DECLARATION OF ROBERT C. WEISS

Applicant:	}	Group Art Unit: 291 RECEIVED
MAG INSTRUMENT, INC.	Ş	Examiner: M. Tung JAN 0 7 1992
Serial No. 410,965	}	GROUP 290
Filed: September 22, 1989)	290
For: FLASHLIGHT)	Los Angeles, CA 90017

RESPONSE TO OFFICIAL ACTION MAILED APRIL 12, 1991 DECLARATION OF ROBERT C. WEISS

EXHIBIT E

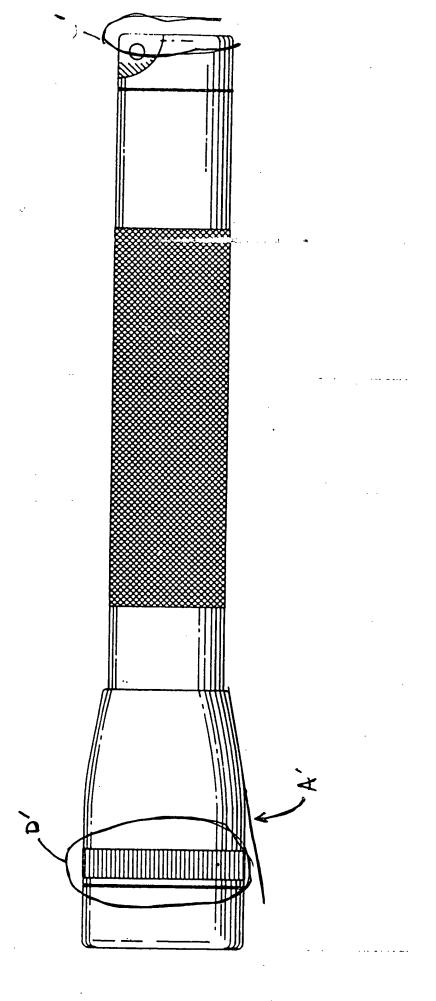
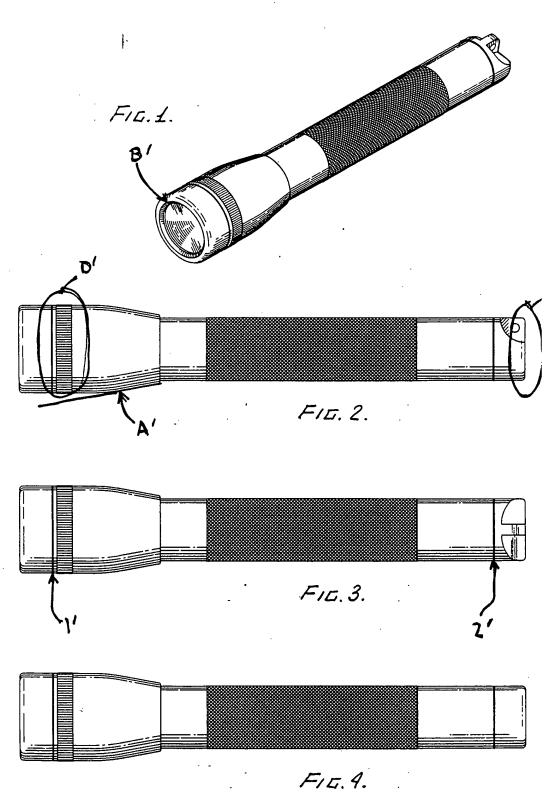
- 7. Attached hereto as Exhibit E is another copy of Exhibit D and a copy of sheet 1 of Exhibit C, with notations A', B', C' and D' to show how the problems with the previous drawings, Exhibit B, have been corrected.

- 8. The Examiner in the Official Action mailed April 12, 1991 referred to four problems with the previous or second set of formal drawings and noted these as "A", "B", "C" and "D". (See Exhibit B). Notation "A" relates to a problem regarding the shape or profile of the head. Notation "B" relates to a problem regarding the outer rim of the edge around the head of the flashlight which the Examiner contended appeared to be more rounded in the second set of formal drawings. Notation "C" relates to the attachment hole end of the flashlight which the Examiner contended had rounder corners in the second set of formal drawings. Notation "D" relates

to the bands on the flashlight head which the Examiner contends should be limited to one thin band and one knurled band.

- 9. In Exhibit E, A' shows how the profile or shape of the head is the same as the profile or shape of the head of the flashlight shown in Figure 2 of the original 06/648,032 drawings. B' shows how the outer rim of the edge around the lens of the flashlight is flatter. This was done by eliminating any confusing shade lines which extended over the rim in the second set of formal drawings. C' shows how the corners of the attachment hole end of the flashlight have been modified to show a sharper radius. D' shows one thin band and one knurled band on the flashlight head. The thin band is darker because it represents the meeting of two edges. A similar dark band was used to show where the barrel meets the tail cap. See 1 and 2 on Exhibit A and 1' and 2' on Exhibit E.
